Access Compliance Report

Public Rights-of-Way

Intersection ID: 48453	Main Street: ALVARADO_WY	Cross Street: RED_RUST_LN	Location: SW
ADA ID: 5413C645436B	Ramp Type: Perp	Initial Pass/Fail: Fail	Overall Compliance: No
Severity Score: 21.25			
Codes/Mitigation Info/Possible Solution		Field Measurements/Component Compliance

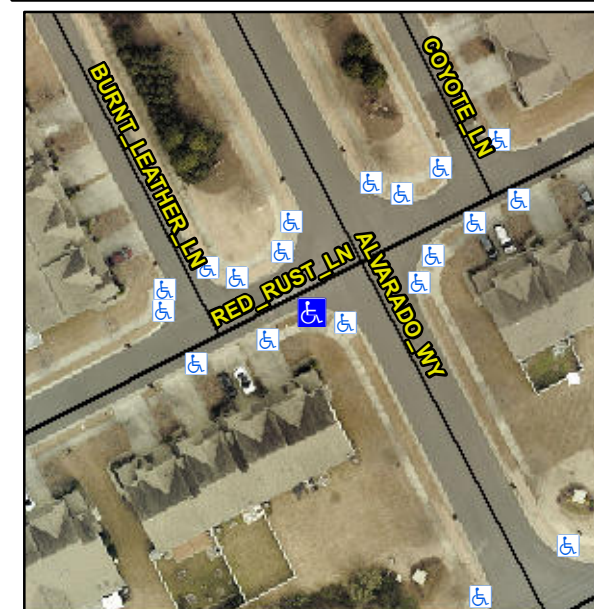
R304.5.1, R304.2.2

Compliance	Description	Data	Compliance	Description	Data
N/A	Ramp Length (in)	77.0	No	Ramp Slope (%)	10.7
No	Ramp Width (in)	47.0	Yes	Ramp XSlope (%)	1.1
N/A	Flare Type LT	N/A	N/A	Flare Type RT	N/A
N/A	Flare Slope LT (%)	N/A	N/A	Flare Slope RT (%)	N/A
N/A	Flare Traversable LT?	N/A	N/A	Flare Traversable RT?	N/A
N/A	Landing Length (in)	N/A	N/A	DWS Provided?	N/A
N/A	Landing Width (in)	N/A	N/A	DWS Contrast?	N/A
N/A	Landing Slope (%)	N/A	N/A	DWS Length (in)	N/A
N/A	Landing X Slope (%)	N/A	N/A	DWS Full Width?	N/A
N/A	Landing Curb? (Y/N)	N/A	N/A	DWS Offset (in)	N/A
N/A	Shared Landing?	N/A			
N/A	Gutter Ponding?	N/A	N/A	Gutter Slope (%)	N/A
N/A	Gutter Lip Ht (in)	N/A	N/A	Gutter X Slope (%)	N/A
N/A	Painted X Walk1?	No	N/A	Painted X Walk2?	N/A
	X Walk 1 Direction	To NW		X Walk 2 Direction	N/A
N/A	X Walk 1 Width (in)	N/A	N/A	X Walk 2 Width (in)	N/A
	X Walk 1 Slope (%)	2.5		X Walk 2 Slope (%)	N/A
	X Walk 1 X Slope (%)	0.3		X Walk 2 X Slope (%)	N/A

Remove & Replace Entire Ramp.
